STAFF REPORT
COMMUNITY DEVELOPMENT DEPARTMENT

SUBJECT: H-2022-0046
 Sessions Parkway – MDA, PP

LOCATION: 2700 N. Eagle Rd., in the NW 1/4 of
 Section 4, T.3N., R.1E.
 Parcel # S1104233650

FIGURE 3D: MIXED USE REGIONAL CONCEPT DIAGRAM

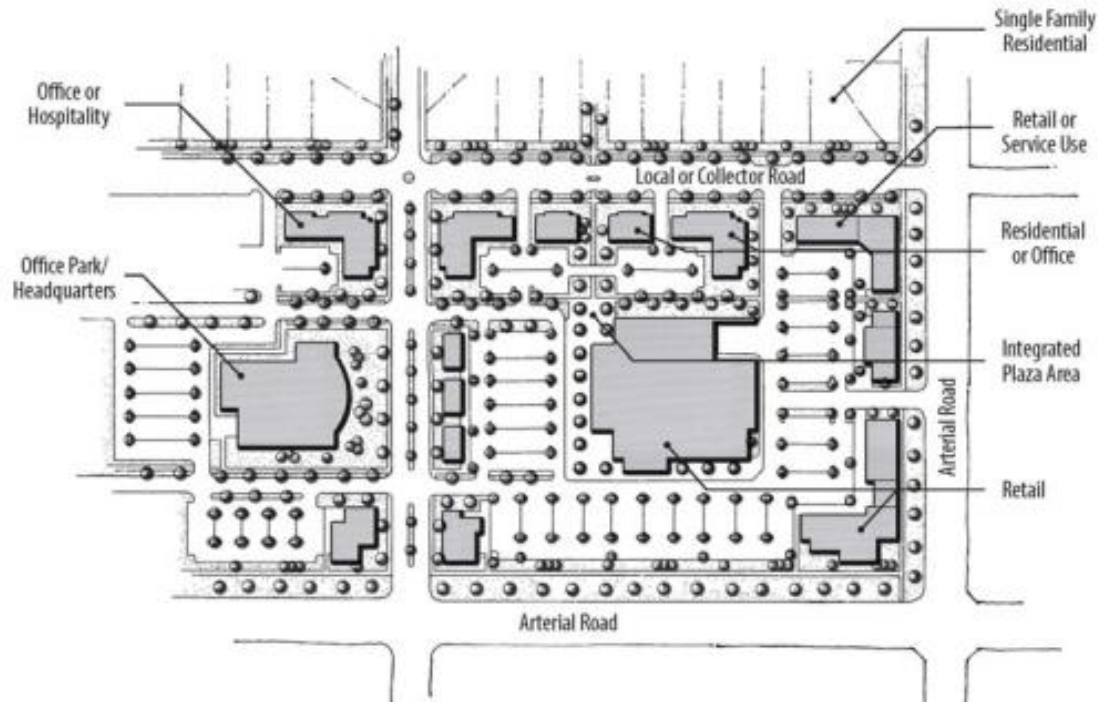
The proposed commercial development is not integrated with the future residential development to the east, nor is there a common usable gathering area with a plaza or green space as desired in mixed use designated areas. The rear of the fuel facility/convenience store faces the backage road and the rear of Buildings C, D and E face the residential development which creates a wall effect. Staff recommends the site plan is revised to more closely align with

the purpose statement and Figure 3D above, and the development guidelines in the Comprehensive Plan for Mixed Use and MU-R designated areas as noted below. Staff suggests rotating the fuel facility/convenience store pad so the rear of the building isn't facing east to better integrate with the other commercial pads and residential development. Similarly, some or all of the buildings along the eastern boundary should be rotated and/or relocated and a shared plaza area/green space added for better integration of uses and consistency with the mixed-use guidelines.

- The site plan should be revised to more closely align with Figure 3D in the Comprehensive Plan for MU-R designated areas (pg. 3-17).
- Make any revisions necessary to the plat and landscape plan based on changes to the conceptual development plan.

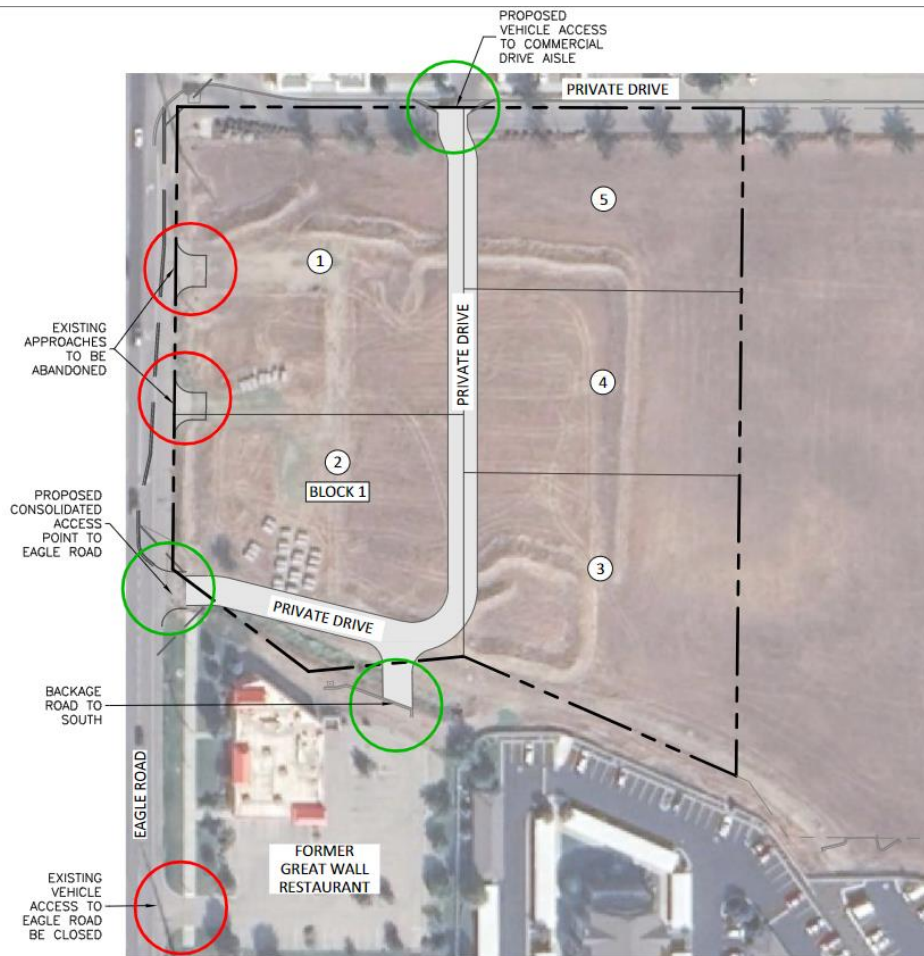
There are two (2) existing accesses on this site associated with the previous residential use(s) and one (1) temporary access on the abutting property to the south via N. Eagle Rd./SH-55 that are proposed to be removed and replaced with one (1) new right-in/right-out driveway access on the abutting property to the south as depicted on the plans and as shown below.

Per UDC [11-3H-4](#), the use of existing approaches via the state highway are not allowed to continue if the intensity of the use increases. With the change in use to commercial, the intensity of the use will increase; therefore, the existing approaches are not allowed to remain and must be abandoned and removed as proposed. New approaches directly accessing a state highway are only

allowed at the section line road and the half mile mark between section line roads, which does not apply in this case. **City Council may consider and approve modifications to the standards in UDC 11-3H-4 upon specific recommendation of the Idaho Transportation Department (ITD) or if strict adherence is not feasible, as determined by City Council.**

SHEET
A1.0
 OVERALL SITE EXHIBIT

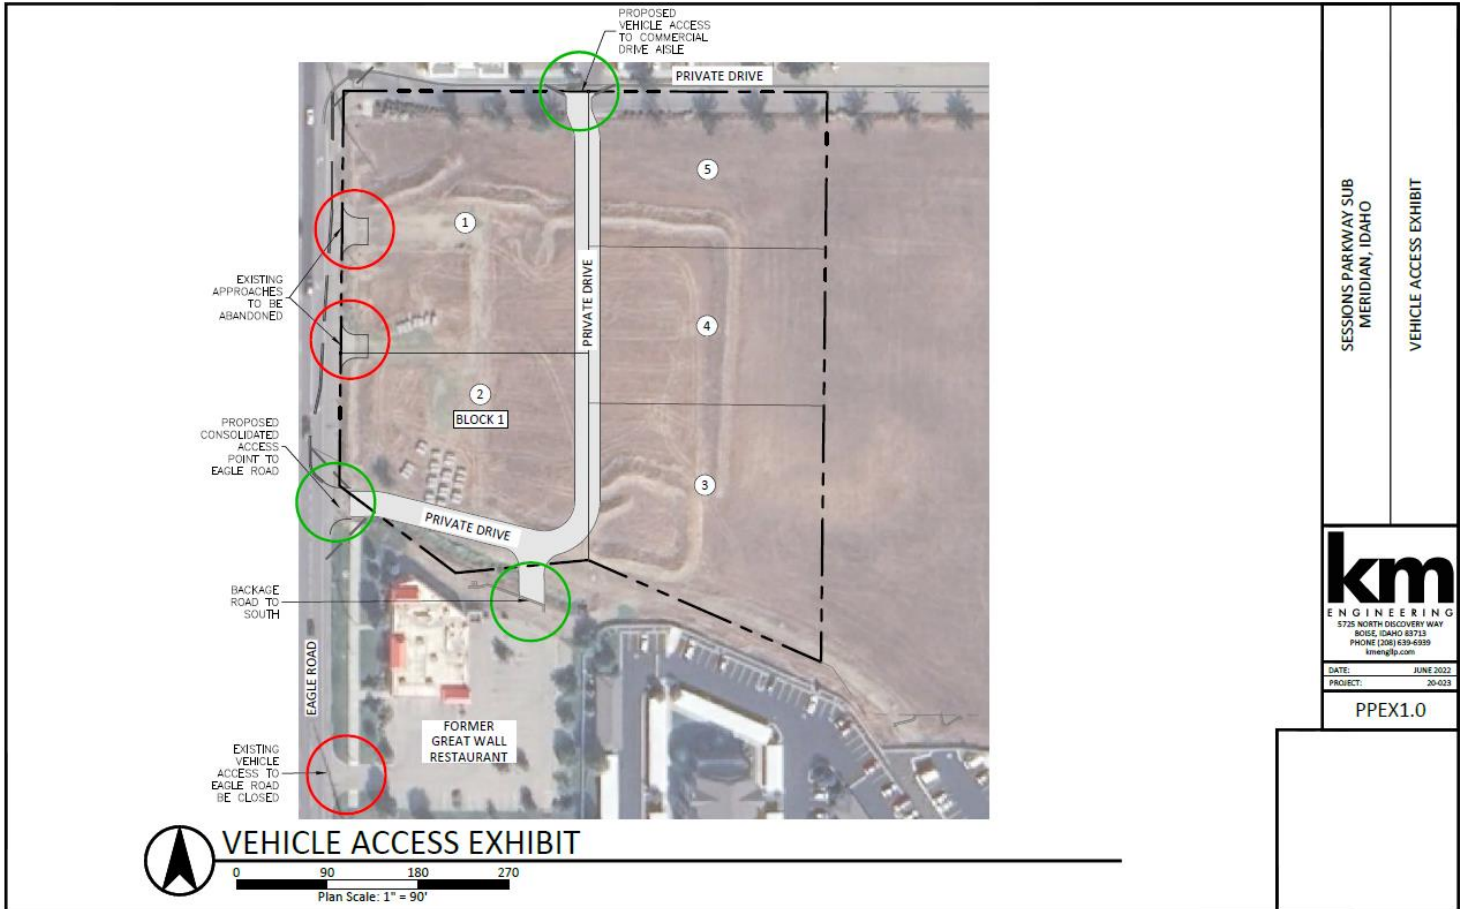
The existing conceptual development plan depicts three (3) retail/commercial building pads along the frontage of N. Eagle Road, two (2) of which are drive-through establishments, and one (1) larger retail building east of the building pads fronting on Eagle Rd. totaling 28,500 square feet (s.f.). A driveway is depicted at the northeast corner of the site for vehicular connectivity with the residential development to the east. A driveway is not depicted to the property to the south (fka Great Wall) because when that property developed, access was not required to be provided to this property because of the Finch Lateral, a large irrigation facility that separates the two properties. The properties to the south of the Finch Lateral were to have a backage road along their east boundaries for access via E. River Valley St.
